Access Compliance Report

Public Rights-of-Way (Curb Ramps)

Intersection ID: 10037582	Main Street: SELWYN FARMS LN	Cross Street: N/A	Location: NE
ADA ID: B752C9BBF132	Ramp Type: PerpDiag	Initial Pass/Fail: Fail	Overall Compliance: No
Severity Score: 46.25			
Codes/Mitigation Info/Possible Solution		Field Measurements/Component Compliance

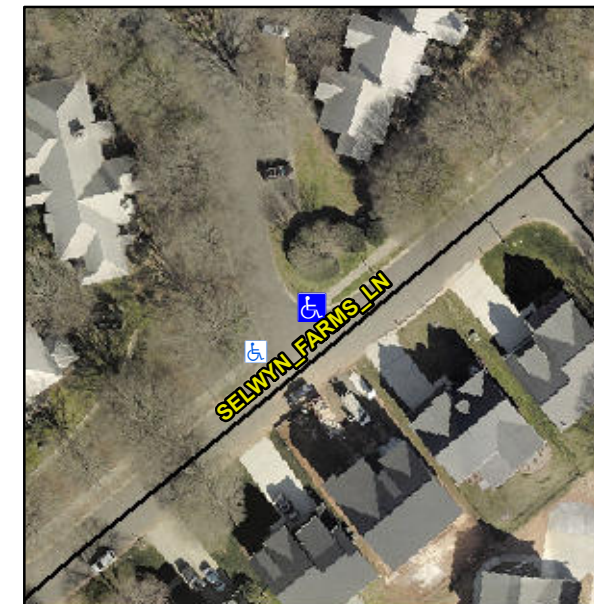
Not Found, R304.5.1, R304.2.2, R304.5.3

Compliance	Description	Data	Compliance	Description	Data
N/A	Ramp Length (in)	38.0	No	Ramp Slope (%)	11.9
No	Ramp Width (in)	47.0	No	Ramp XSlope (%)	12.1
N/A	Flare Type LT	N/A	N/A	Flare Type RT	N/A
N/A	Flare Slope LT (%)	N/A	N/A	Flare Slope RT (%)	N/A
N/A	Flare Traversable LT?	N/A	N/A	Flare Traversable RT?	N/A
N/A	Landing Length (in)	N/A	N/A	DWS Provided?	N/A
N/A	Landing Width (in)	N/A	N/A	DWS Contrast?	N/A
N/A	Landing Slope (%)	N/A	N/A	DWS Length (in)	N/A
N/A	Landing X Slope (%)	N/A	N/A	DWS Full Width?	N/A
N/A	Landing Curb? (Y/N)	N/A	N/A	DWS Offset (in)	N/A
N/A	Shared Landing?	N/A			
N/A	Gutter Ponding?	N/A	N/A	Gutter Slope (%)	N/A
N/A	Gutter Lip Ht (in)	N/A	N/A	Gutter X Slope (%)	N/A
N/A	Painted X Walk1?	No	N/A	Painted X Walk2?	No
	X Walk 1 Direction	To SW		X Walk 2 Direction	To SE
N/A	X Walk 1 Width (in)	N/A	N/A	X Walk 2 Width (in)	N/A
	X Walk 1 Slope (%)	0.0		X Walk 2 Slope (%)	6.3
	X Walk 1 X Slope (%)	5.6		X Walk 2 X Slope (%)	1.8

Remove & Replace Curb Ramp With Two New Directional Ramps or Equivalent.
